SUBJECT: N0516/17 – 701-703 Barrenjoey Road, Avalon Beach (Lot 1 DP 12074, Lot 2 DP 12074) - Construction of a four (4) unit Seniors Living development with basement car parking, landscaping and strata subdivision

SUMMARY OF RECOMMENDATION: CONSENT WITH CONDITIONS

Figure 4: Extract of the northern elevation plan; elements above the red line would not comply with the envelope.

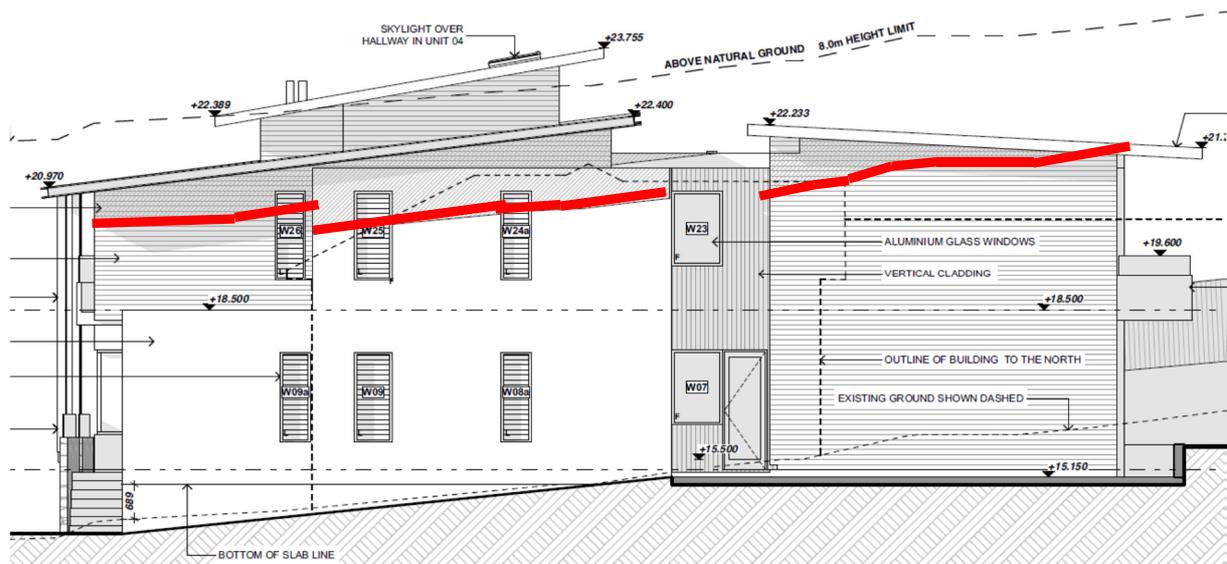
As indicated by the plans, part of the northern side elevation would not comply with the building envelope. Due to the articulation of this elevation, the height of the noncompliance varies, though at its maximum point the variation would be 1.4m high and would extend for the entire length of the affected elevation (see figure 4). The applicant acknowledges the noncompliance and justifies it on the basis that there would be no adverse impacts on surrounding sites and the visual impact of the noncompliance would be screened by vexation that is proposed along the northern boundary.

It is agreed that adverse impacts on the adjoining site would be unlikely; the development would not affect views nor would it overshadow sites to the north. Subject to conditions regarding screening, overlooking of the adjoining site to the north should also be prevented prior to boundary vegetation becoming properly established.

As the outcomes of the control would be met and the amenity of adjoining sites would be retained, the noncompliance is considered to be supportable on merit.
